PLANNING AND DEVELOPMENT SERVICES STAFF REPORT

For Planning Commission Meeting of October 15, 2013

**SUBJECT: Briarwood Restaurants Rezoning and Site Plan for City Council Approval
700 Briarwood Circle
File No. SP13-036**

MACY'S PROPOSED SITE PLAN

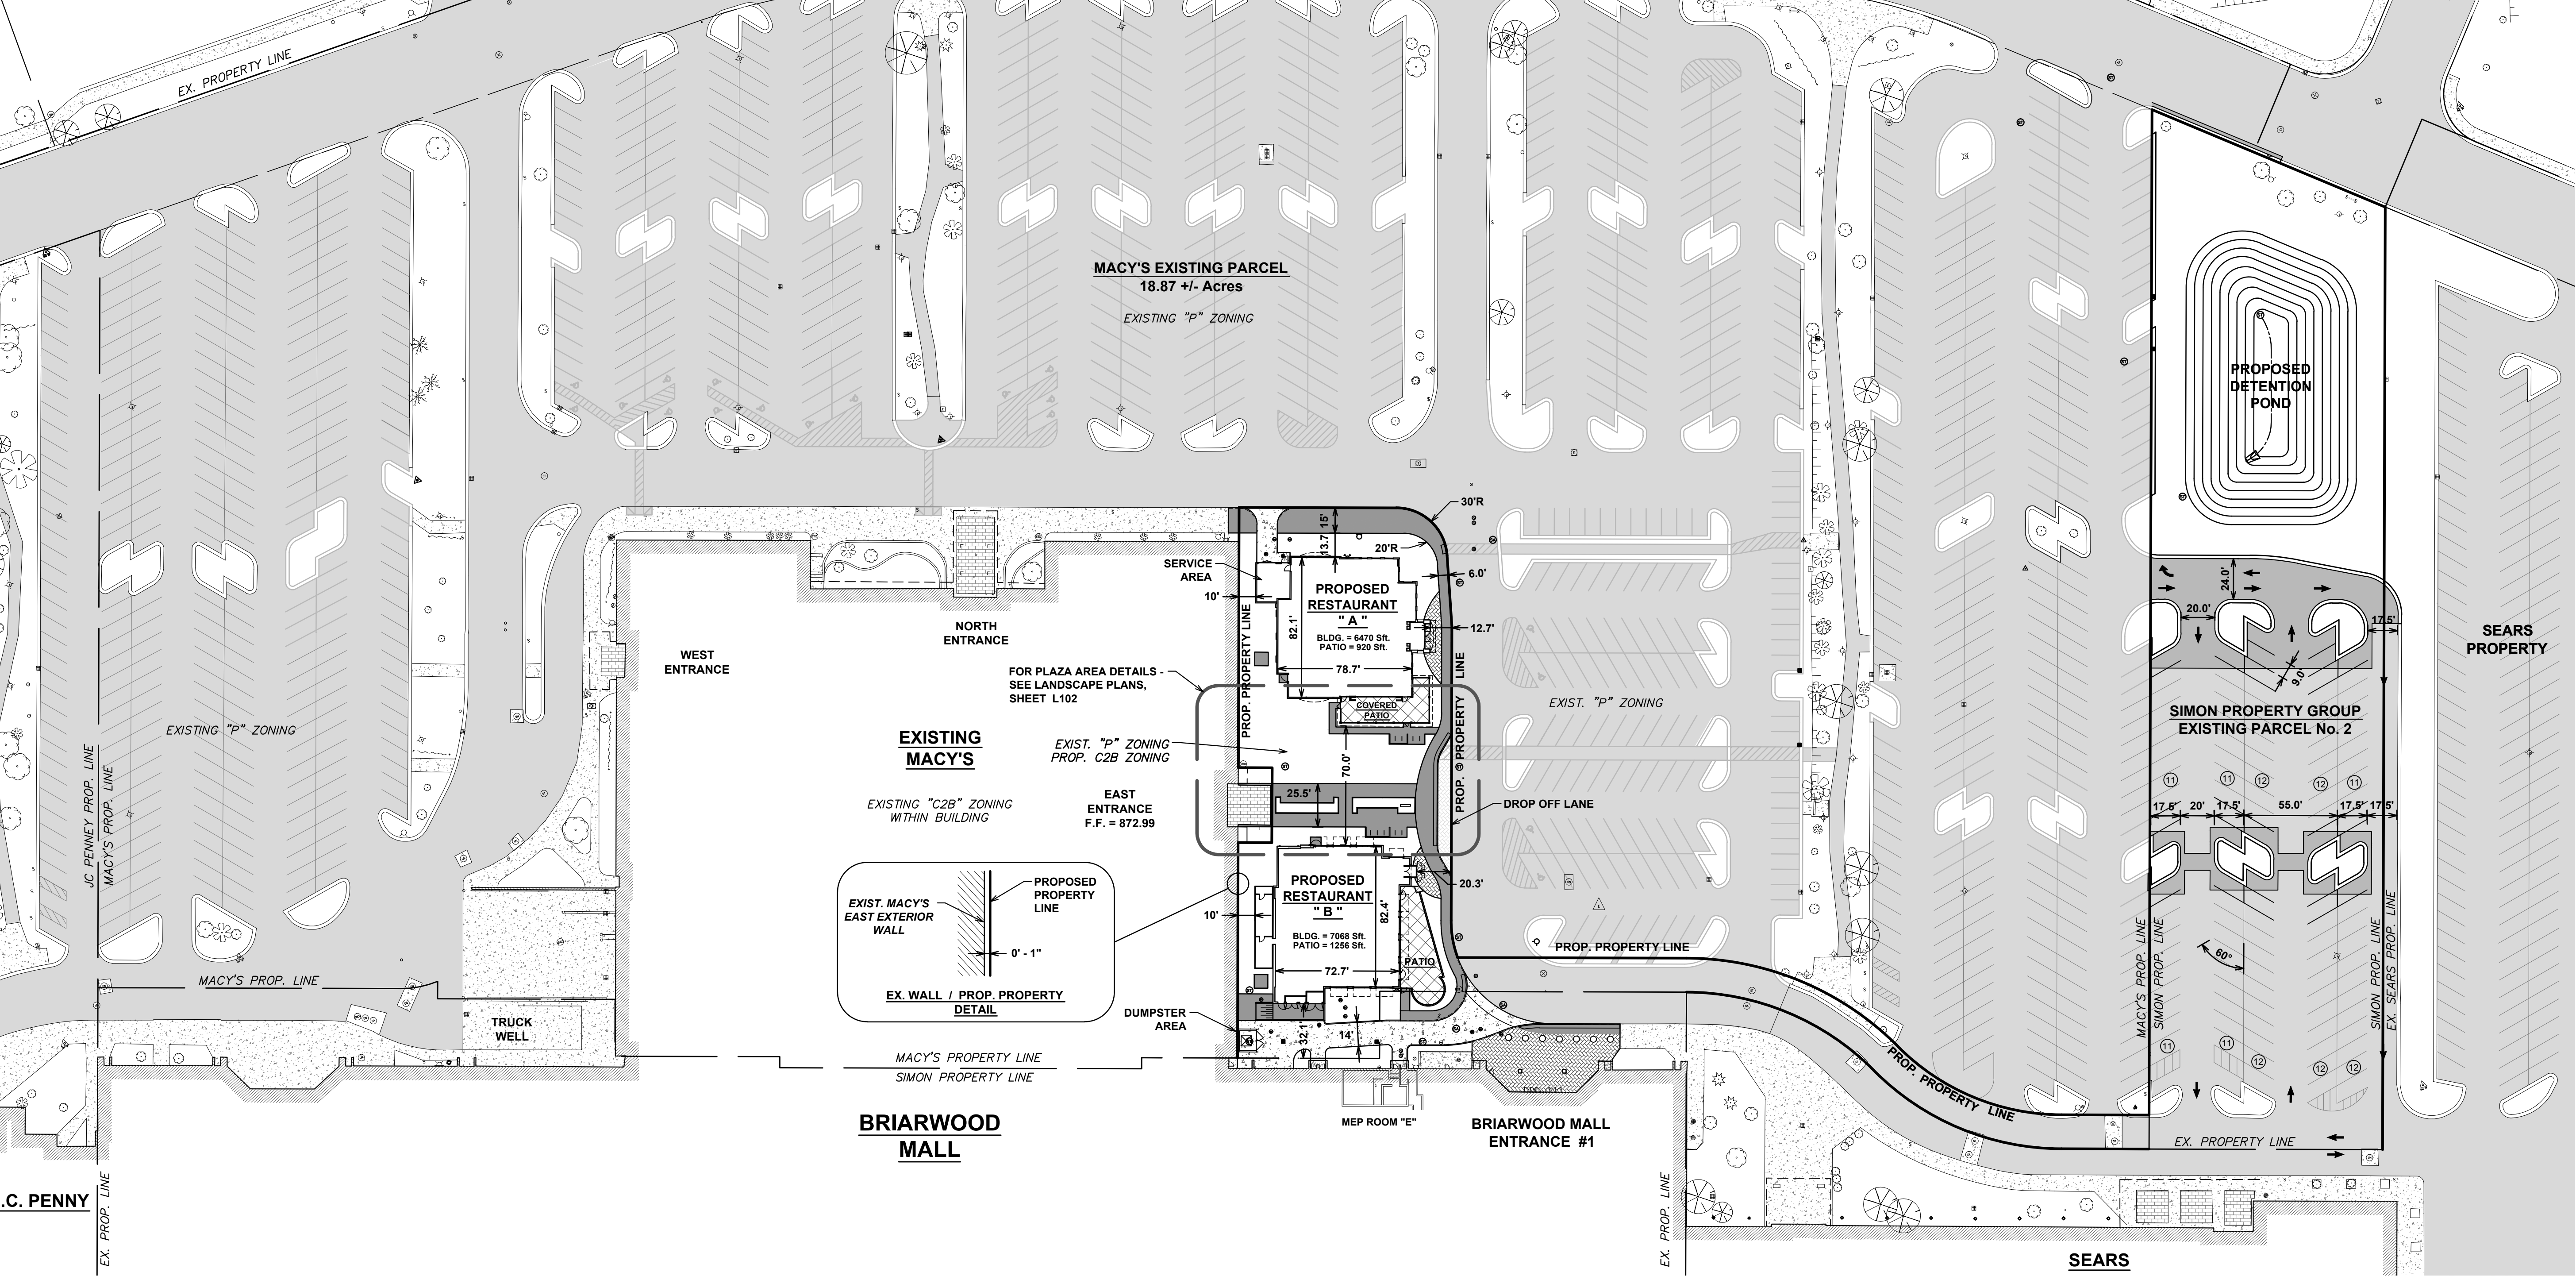
Fire - The entire footprint for Macy's does not meet the 250 foot hydrant radius requirement. The site plan shows two hydrants, one on the northwest and the other on the northeast of Macy's. However, the Fire Marshall has indicated that they are Post Indicator Values (PIV's) and not hydrants; they cannot be used to meet hydrant radius requirements. The proposed FDC for proposed restaurant A does not meet the minimum 100 foot distance from a supporting hydrant.

Systems Planning – Natural Resources - Per Chapter 62 5:602(2)(d), a maximum of 15 parking spaces are allowed in a row without a landscape island break. A maximum of 20 continuous spaces will be permitted if larger landscape islands have been combined and are used for bio-retention. The parking lot has several rows that exceed 15 parking spaces in the row and the combined island requirement has not been met.

PROPOSED SITE PLAN

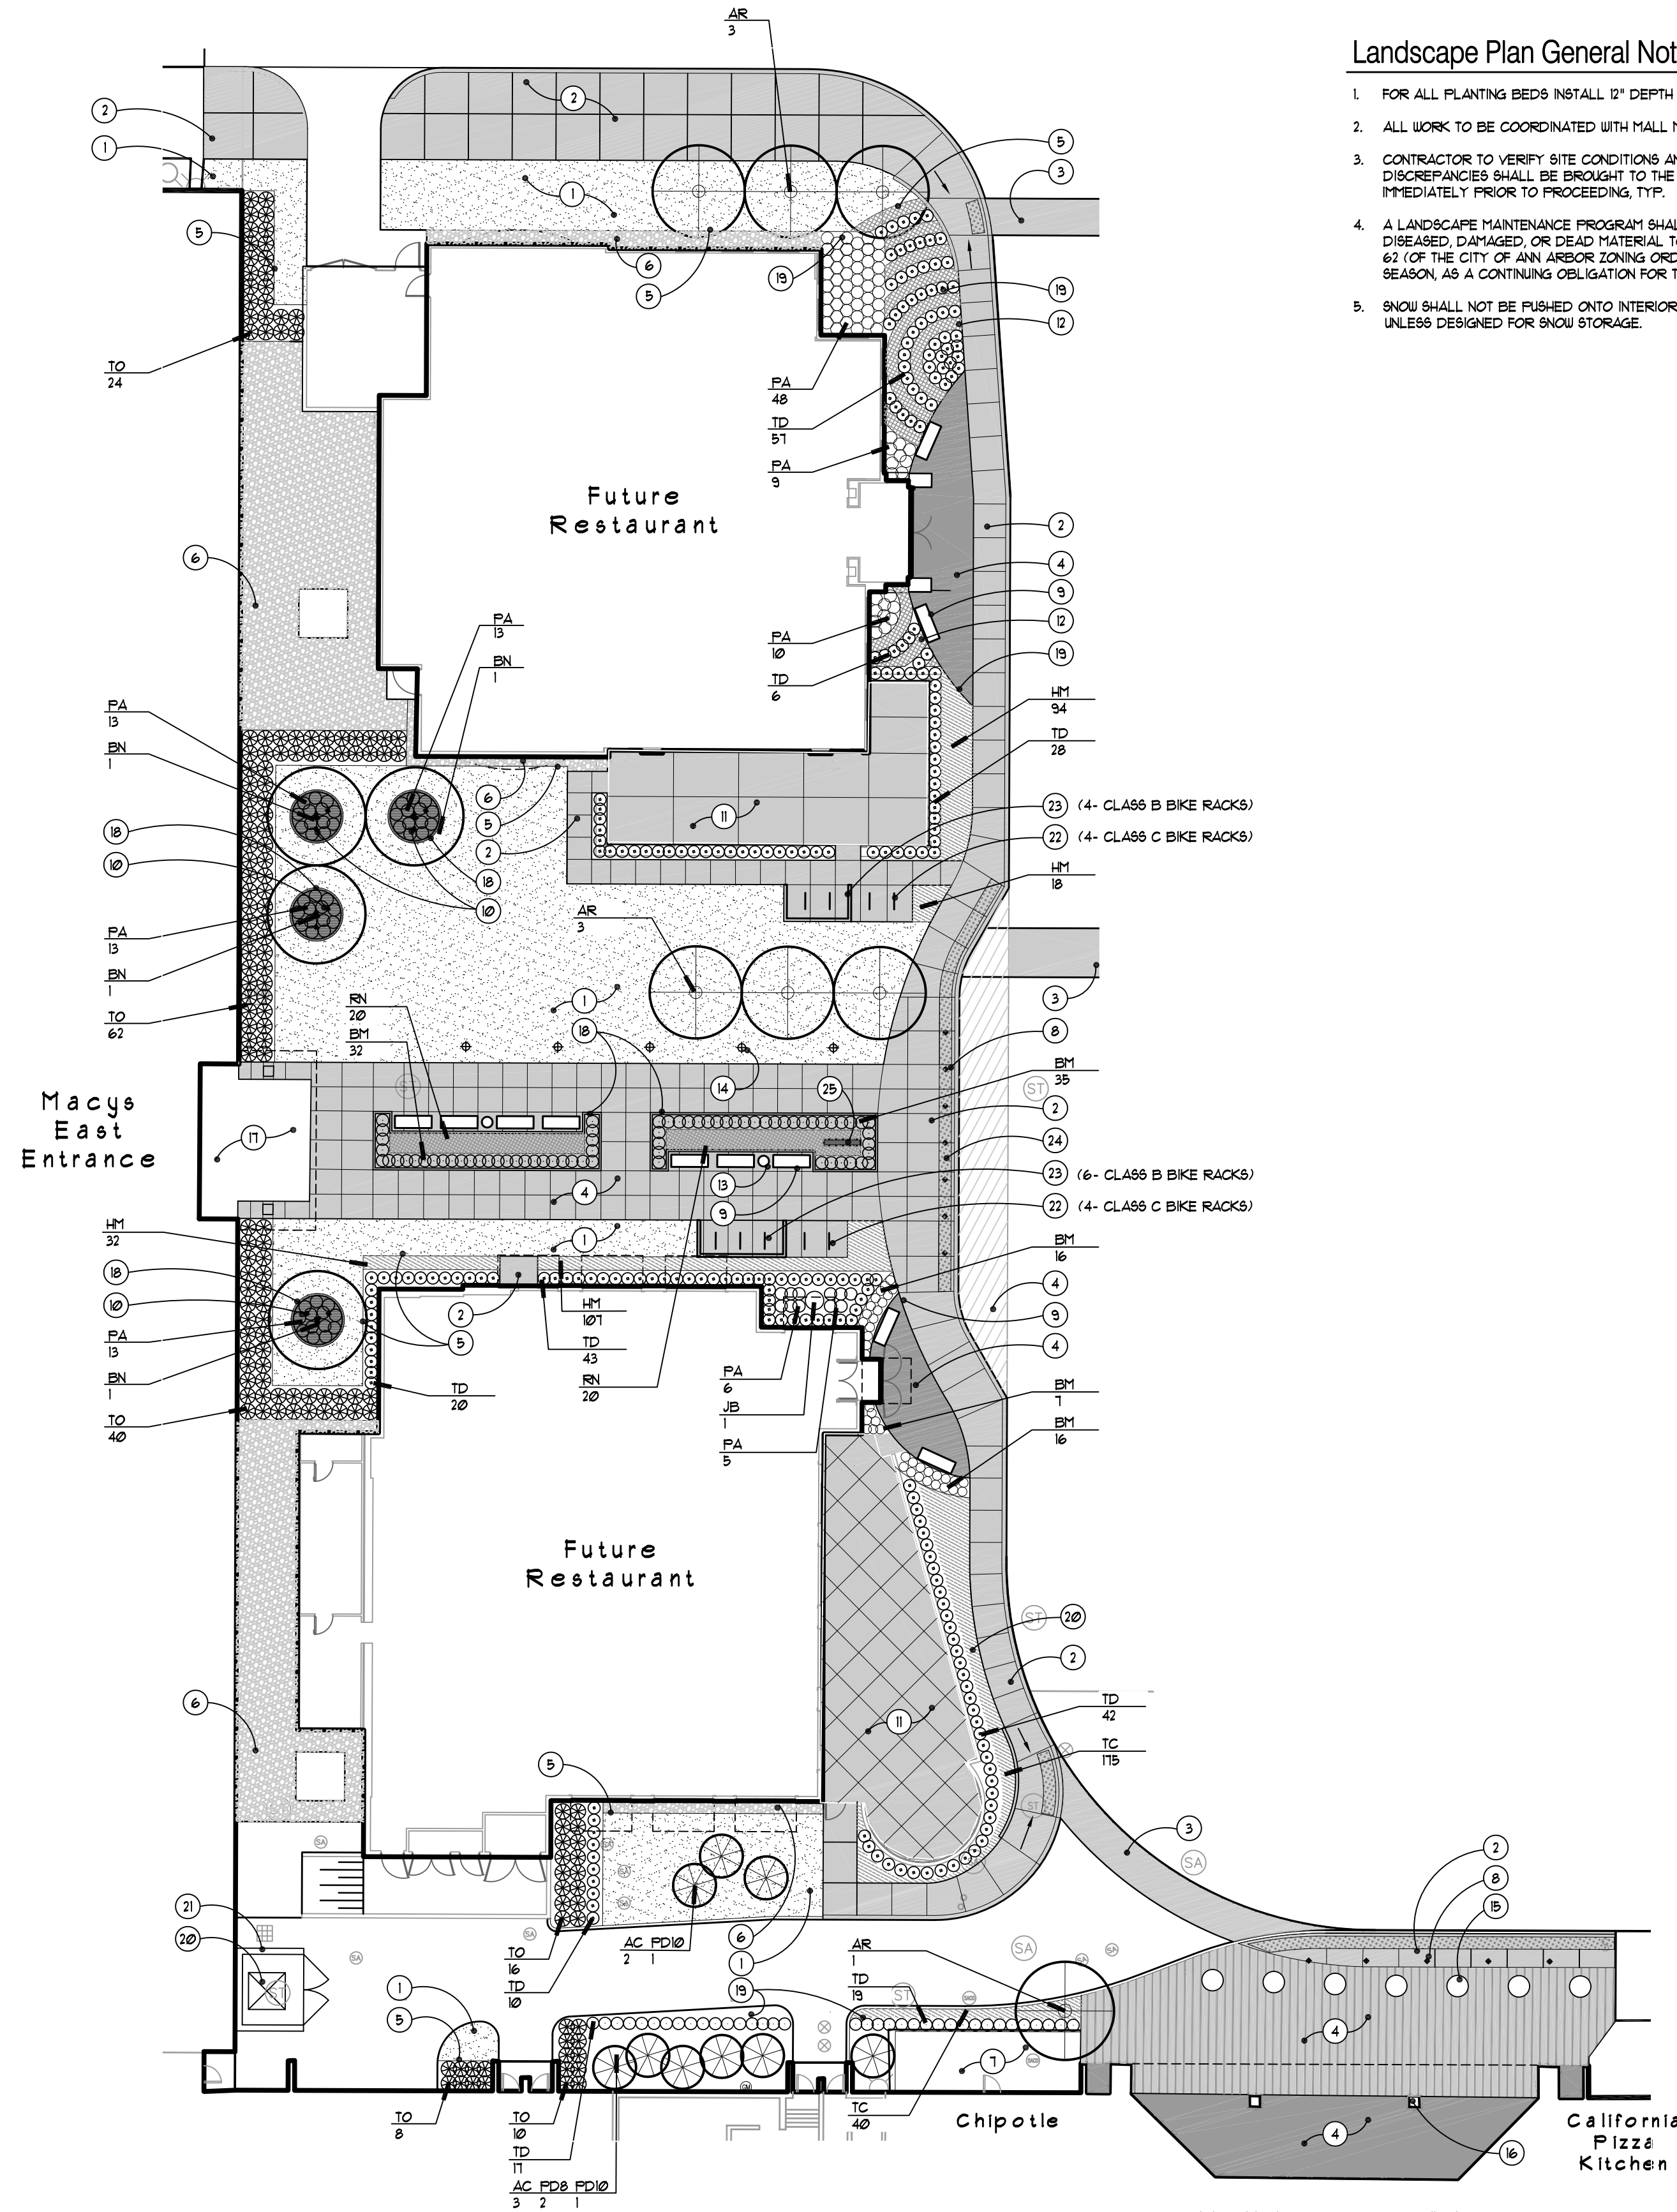
Systems Planning - Solid Waste - The dumpster areas for these restaurants need to be widened to 20 feet clear opening to allow space for a second dumpster for recycling.
